Objection submission COM/2019/81 -

Updated 'Stormwater Management Plan' problems and observations

Attachment A2 - 'Groundwater Impact Assessment' - showing best case and worst case scenarios

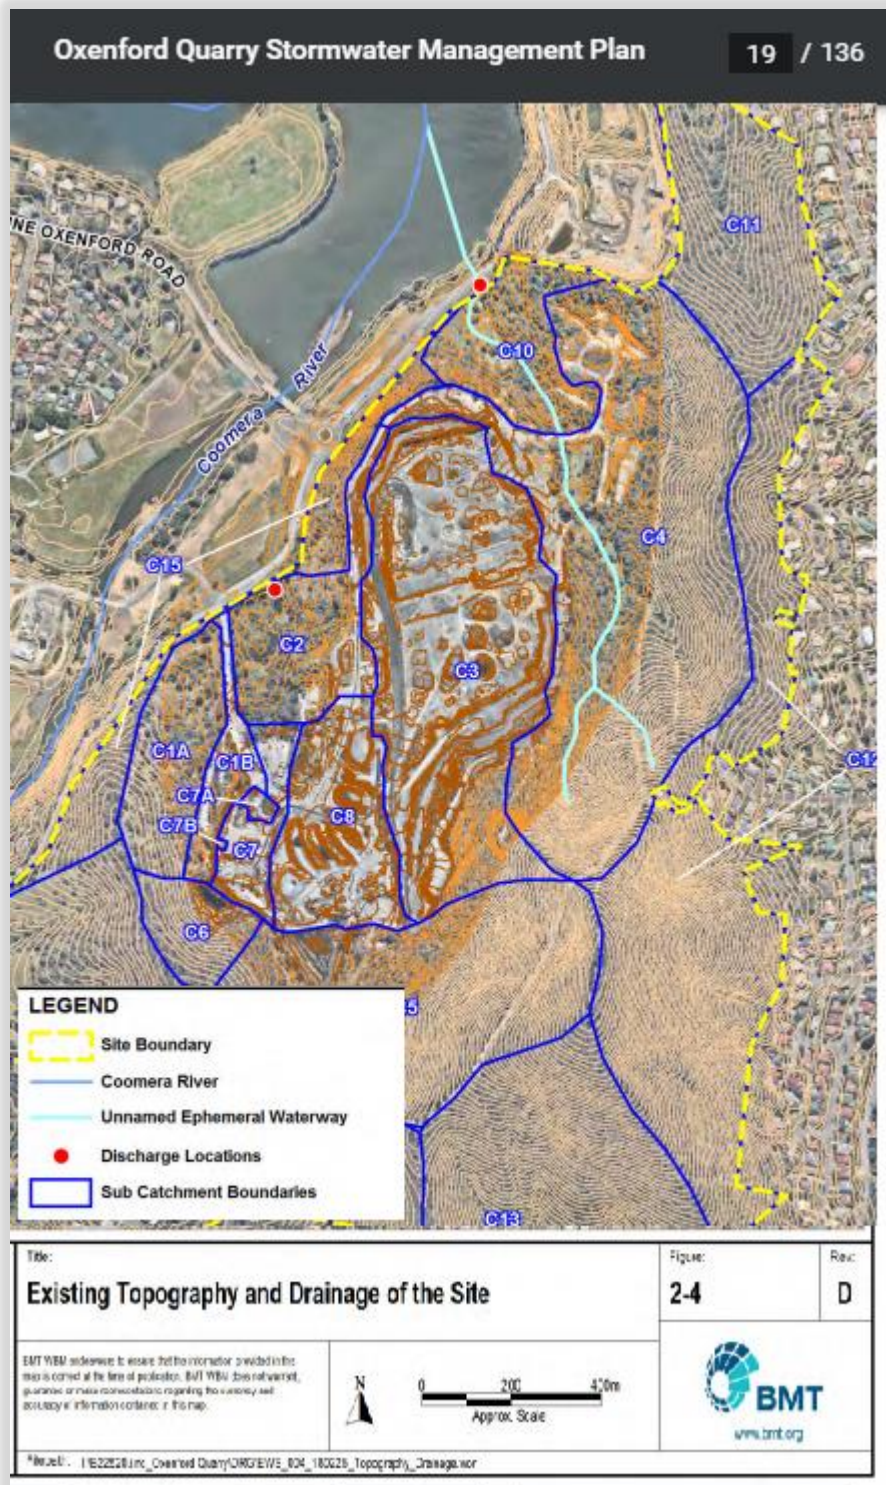
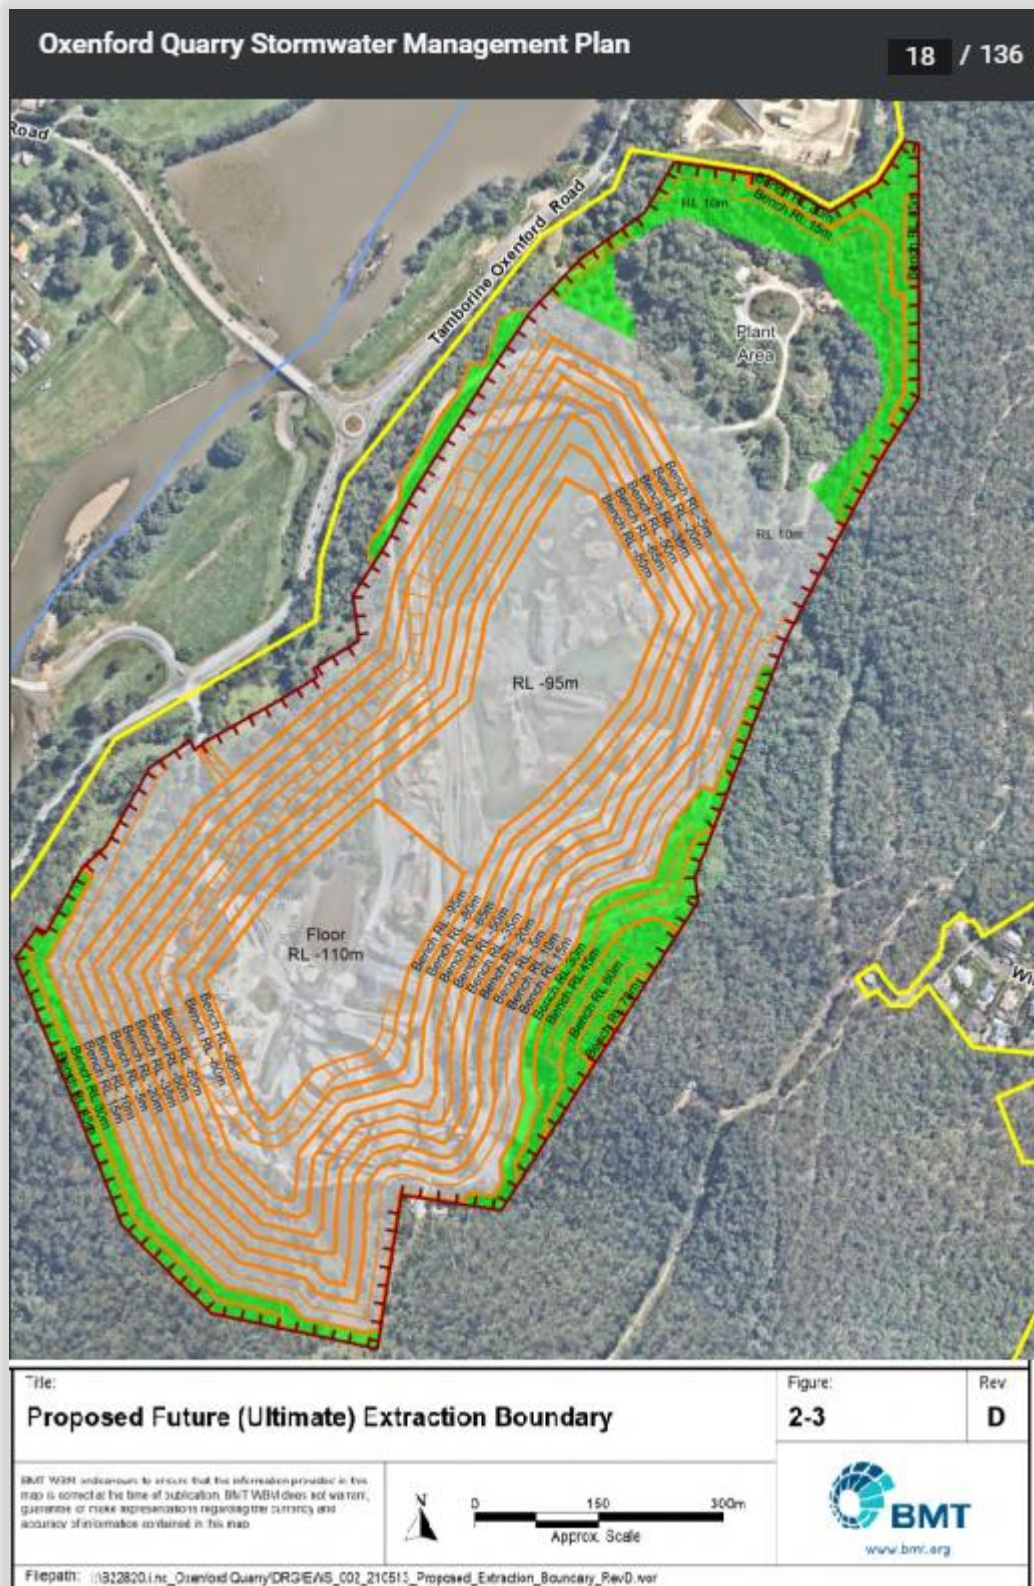
However, in the Groundwater Impact Assessment the low bedrock conductivity scenario is merely the best case option at '130 ML/yr'. In the case of 'High bedrock conductivity' there is an estimated '180 ML/yr' and in the case of 'High bedrock wall and floor conductivity' there is an estimated '432 ML/yr'. (Attachment A2) or 13.7 L/s. A significant difference from the *"Based on this statement, the groundwater inflow as anticipated at being 4 L/s (345.6m³/d) for the quarry Pit Sump C3 for the ultimate site conditions"*.

I do not believe calculations can be based on *"low bedrock conductivity scenario ... are considered more likely to be representative of the magnitude of inflows to be observed during operations"*. Clearly this is a mere 30% of the inflow than could be observed. Without actual proof that it is safe to assume this 'best case scenario' then the 'worst case scenario' should be adopted. Why is there a best case scenario and a worst case scenario if the applicant is just going to pick the best option? It would thus seem, this Stormwater Management Plan is based on the assumption the inflow from the pit floor and pit walls is going to be a mere 30% of the worst case scenario. Hardly a solid foundation

to a 'Stormwater Management Plan' when you are assuming the groundwater inflow is going to be 3/10th of what may be witnessed.

Similarly, the 'Radius of influence' is going to be assumed to be 700 metres (best case scenario) whereas it could just as easily be 1.418 km (worst case scenario) as clearly shown in Attachment A2. Again, hardly a solid foundation to a 'Stormwater Management Plan' when you are assuming the 'Radius of Influence' is going to be an area of 1,538,600 m², around the quarry, when in fact it could be an area up to 6,313,673m² (Which is over four times the size and incorporated hundreds of additional homes and businesses throughout the area).

Figure 3: Schematic Diagram of Recommended Stormwater Management Practices

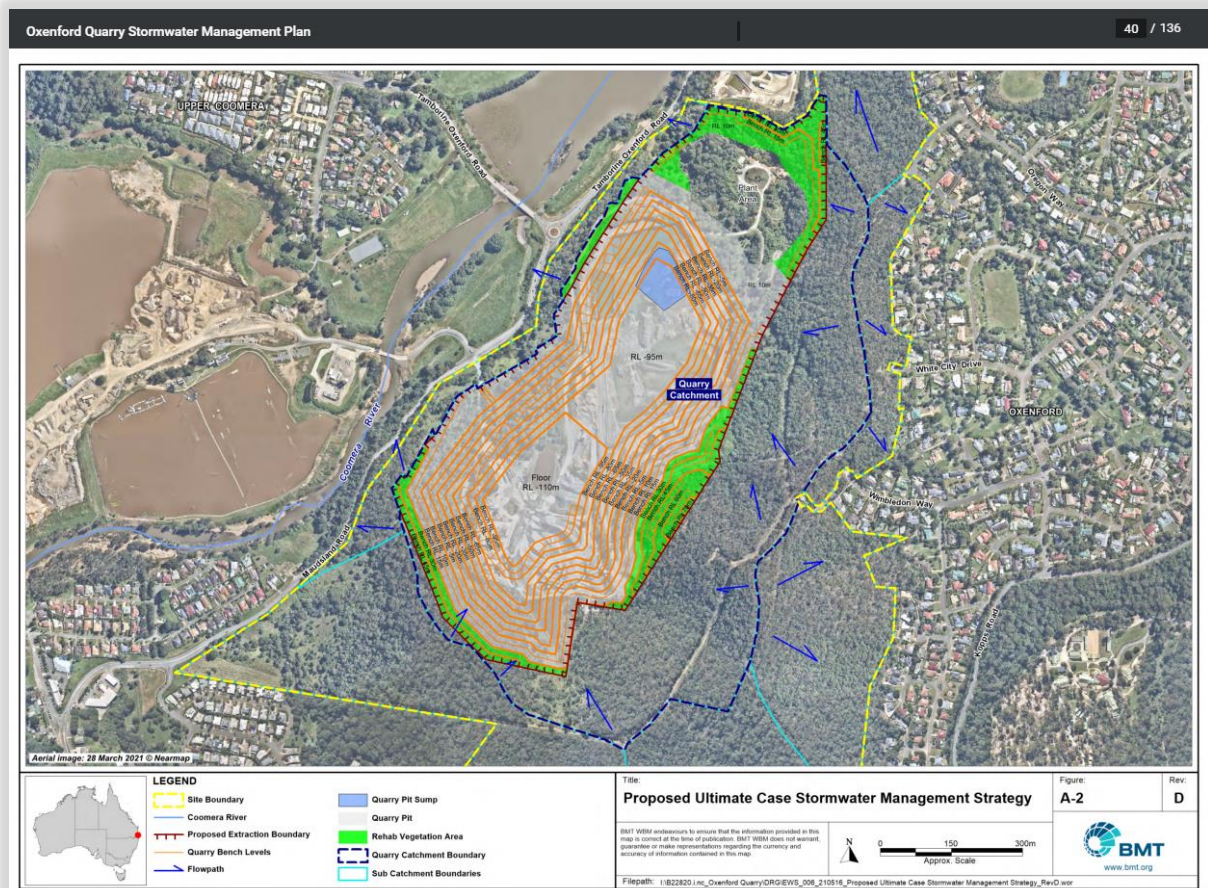
In the '*Schematic diagram of Recommended Stormwater Management Practices*' - Figure 3 it can clearly be seen that it is claimed there will be a discharge to the Coomera River of 90.69 ML/yr (reproduced in Attachment E1). However, this is a distinct contradiction to Table C-8 which shows the discharge to be between 933 ML/yr and 890 ML/yr (Attachment D1).

Why is this diagram seeking to convince the reader the discharge to the Coomera River is less than 10% of the actual figure?
